CHRISTOPHER M. FALLON
Vice President
Nuclear Development

Serial: NPD-NRC-2014-021
June 27, 2014

**LEVY NUCLEAR PLANT, UNITS 1 AND 2
DOCKET NOS. 52-029 AND 52-030
PARTIAL RESPONSE TO NRC RAI LETTERS 116, 117 and 118 – SRP SECTIONS 6.3 AND
15.2.6**

Figure 2: Non-Dimensional Film Thickness Comparison

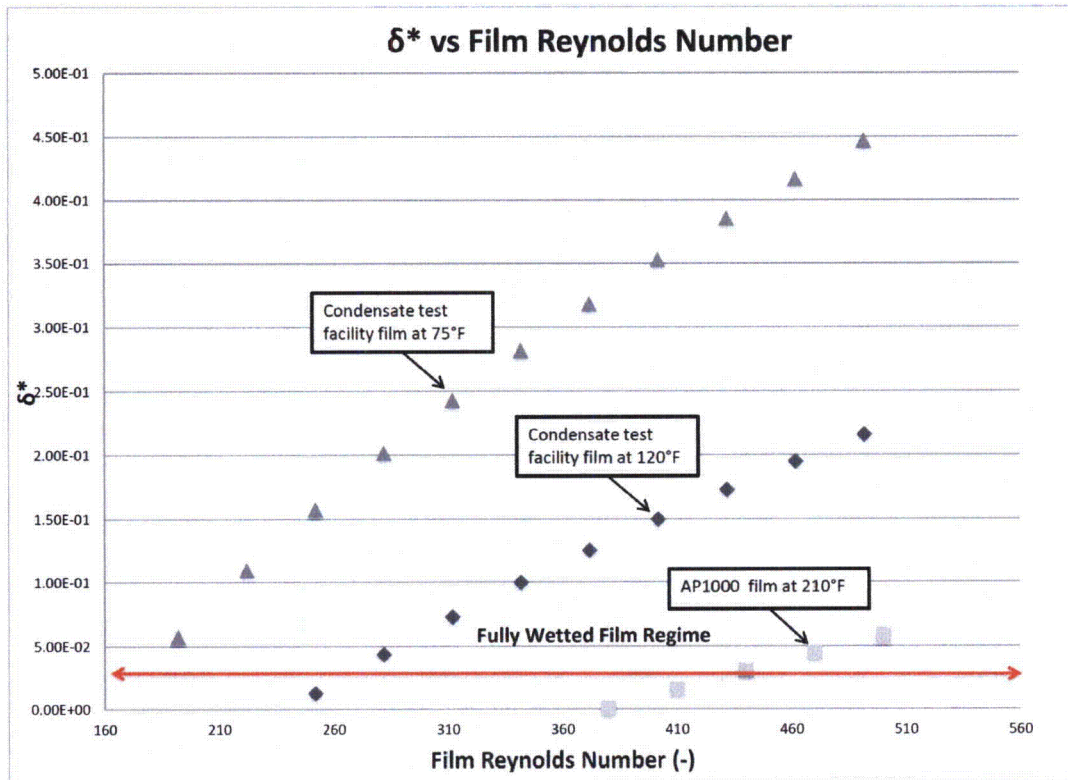
Figure 2 shows the comparison of non-dimensional film thickness versus film Reynolds number for the condensate return test facility and the **AP1000** design conditions. The figure shows that at the same film Reynolds number, non-dimensional film thickness is greater in the condensate return test facility than for the **AP1000** design conditions. Hence, % losses at the attachment plates in the film regime are conservatively larger in the condensate return test facility.

In summary, justifying extrapolation of test results in Reference 8 for temperature extrapolation to the **AP1000** design is justified in that the geometry and surface related characteristics are preserved and the film Reynolds number bounded in the condensate return test, the attachment plate condensate loss data is applicable to the **AP1000** design. Less than prototypic condensate temperature in the test facility causes larger film thickness at a given film Reynolds number and leads to transition from film to rivulet regime at lower Reynolds numbers in the test relative to the **AP1000** plant. From scaling non-dimensional film thickness, the attachment plate detachment percent and loss data obtained in the condensate return test facility for the film regime is conservatively higher than that expected for the **AP1000** plant.

Figure 1: Nuclear Power

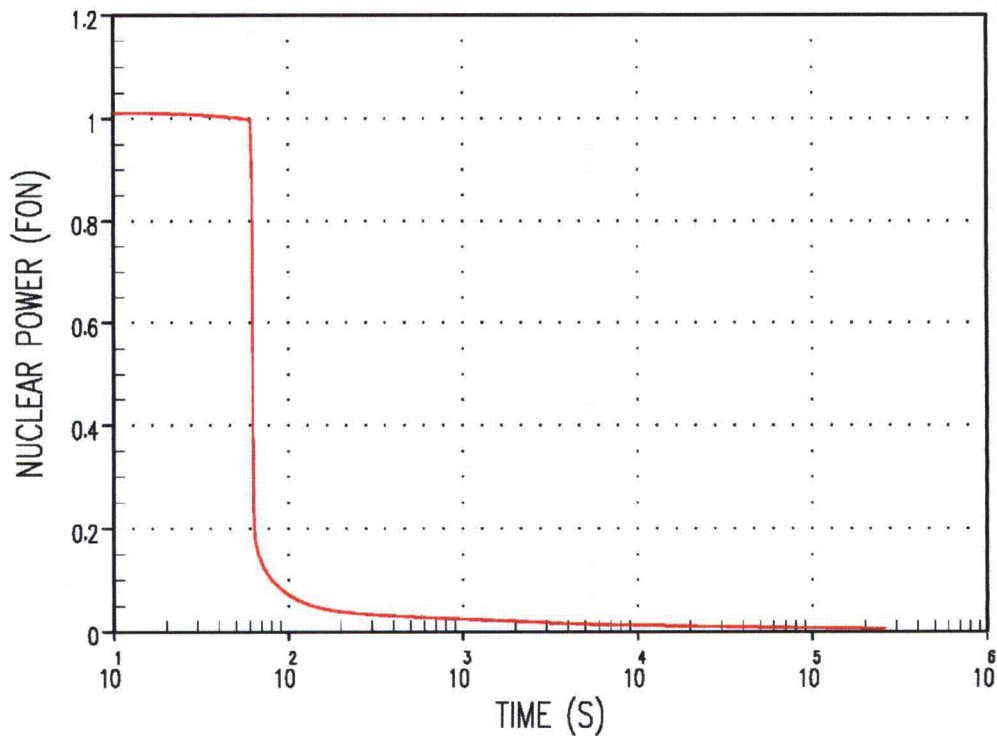
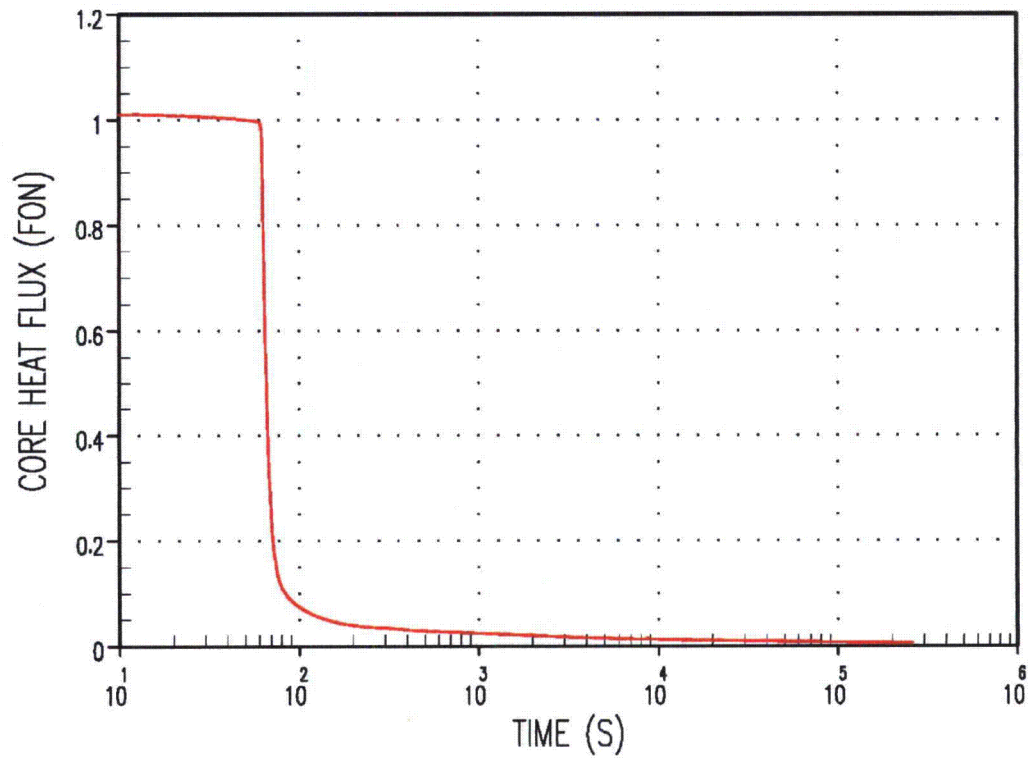
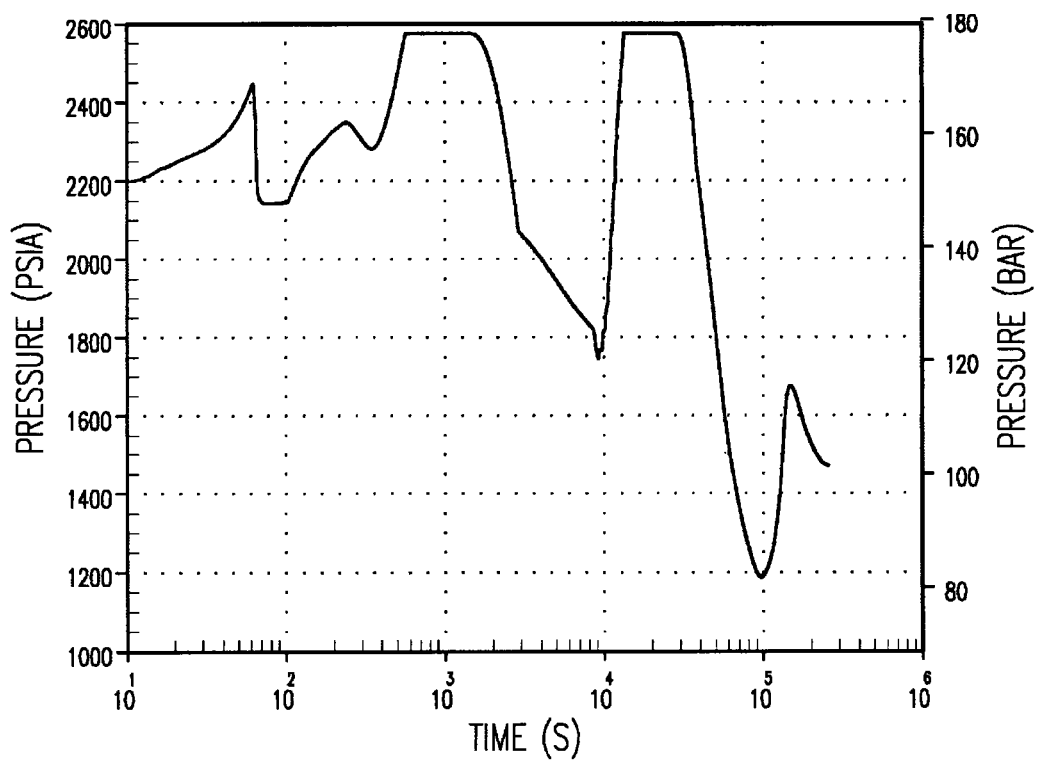
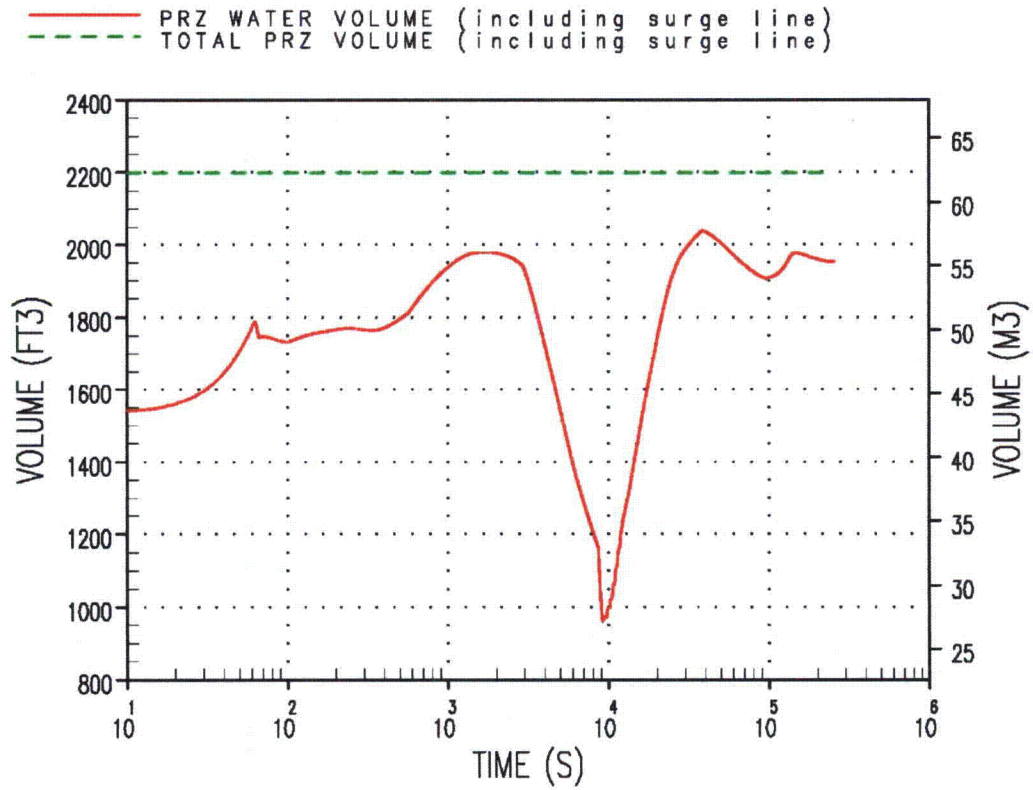
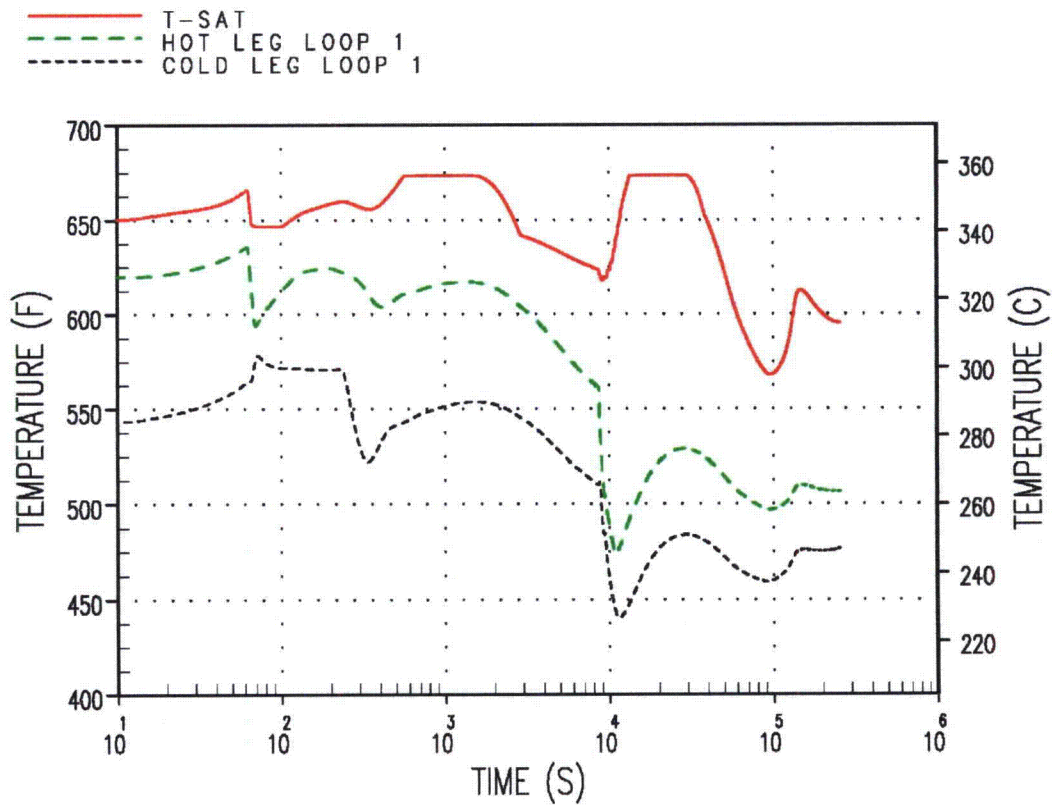
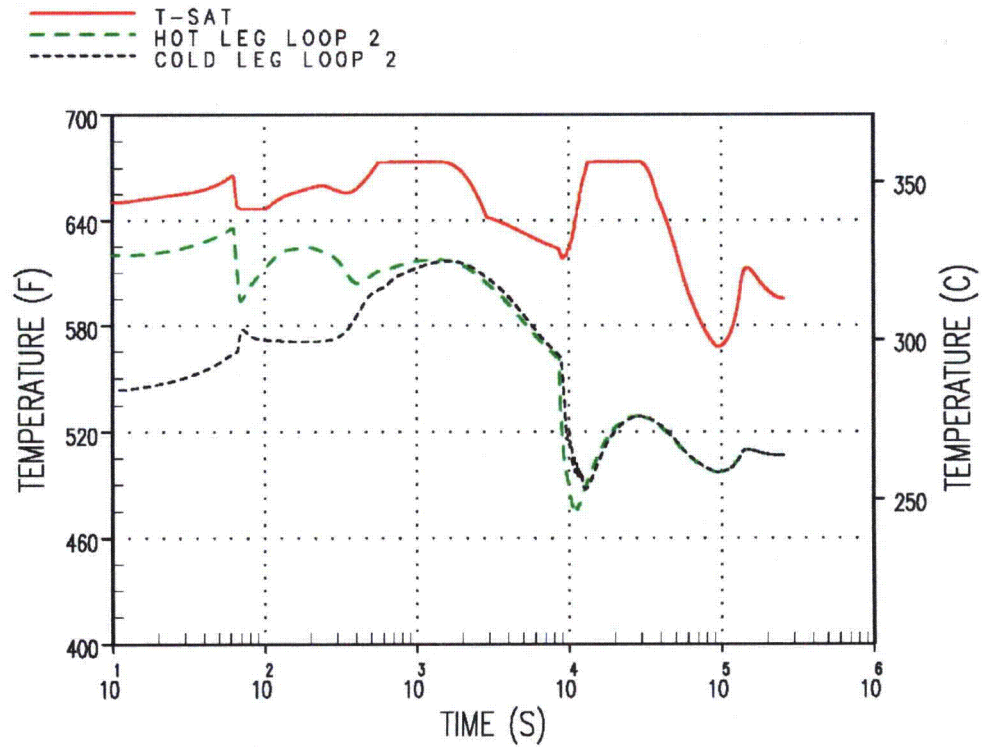
- a. *Provide an explanation as to why loss of normal feedwater coincident with loss of ac power is the limiting event from the standpoint of PRHR-HX performance.*
- b. *Extend the calculation time for the limiting event to 72 hours. In addition to the plots already presented in the DCD include plots for (1) IRWST level as a function of time, (2) condensate return fraction as a function of time, and (3) containment pressure as a function of time.*

The transient response of the reactor coolant system following a loss of normal feedwater with coincident loss of ac power is shown in Figures 1 through 15 including the in-containment refueling water storage tank (IRWST) level as a function of time (Figure 13), the condensate return fraction as a function of time (Figure 14), and the containment pressure as a function of time (Figure 15). The calculated sequence of events for this event is listed in Table 1. Table 2 presents the results for the acceptance criteria of interest.

Figure 19E.4.10-201
**Shutdown Temperature Evaluation,
RCS Temperature**

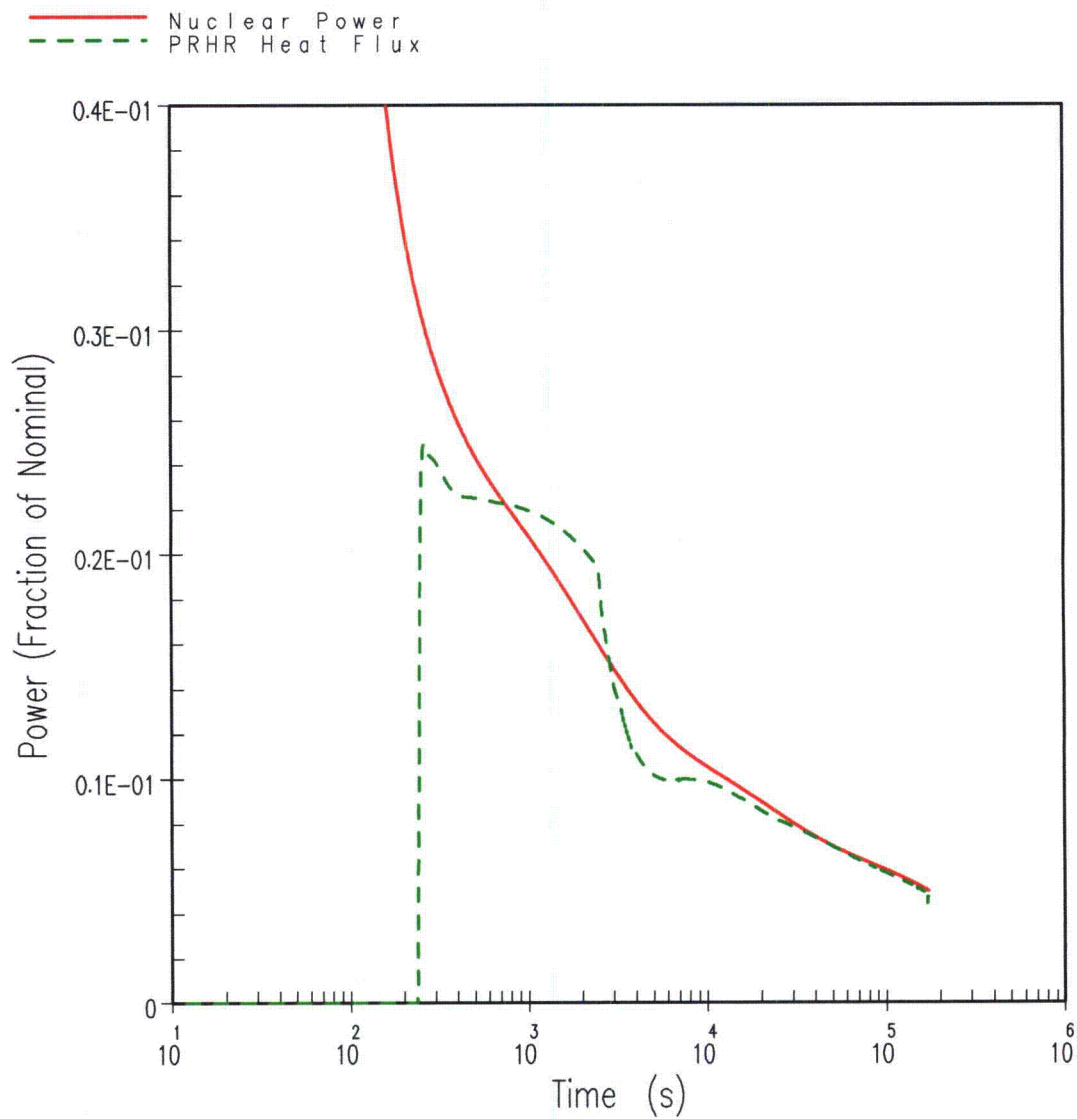
29. COLA Part 2, FSAR Section 19E will be revised to add a departure from DCD Figures 19E.4.10-1 through 19E.4.10-4 as Figures 19E.4.10-201 through 19E.4.10-204, with a LMA of LNP DEP 3.2-1. These figures shall also be added to the list of figures for Chapter 19. Figures 19E.4.10-201 through 19E.4.10-204 are shown in the attachment to this enclosure.

Once actuated, at about 2,400 seconds, the CMTs operate in recirculation mode, injecting cold borated water into the RCS. In the first part of their operation, due to the injection of cold water, the CMTs operate in conjunction with the PRHR HX to reduce RCS temperature. Due to the primary system cooldown, the PRHR heat transfer capability drops below the decay heat and the RCS cooldown is essentially driven by the CMT cold injection flow. However, at about 5,000 seconds, the CMT cooling effect decreases and the RCS starts heating up again (Figure 19.E.4.10-1). The RCS temperature increases until the PRHR HX can match decay heat. At about 34,500 seconds, the PRHR heat transfer matches decay heat and it continues to operate to reduce the RCS temperature to below 420°F within 36 hours. As seen from Figure 19.E.4.10-1, the cold leg temperature in the loop with the PRHR is reduced to 420°F within 48,600 seconds, while the core average temperature reaches 420°F within 124,400 seconds (approximately 34.6 hours).
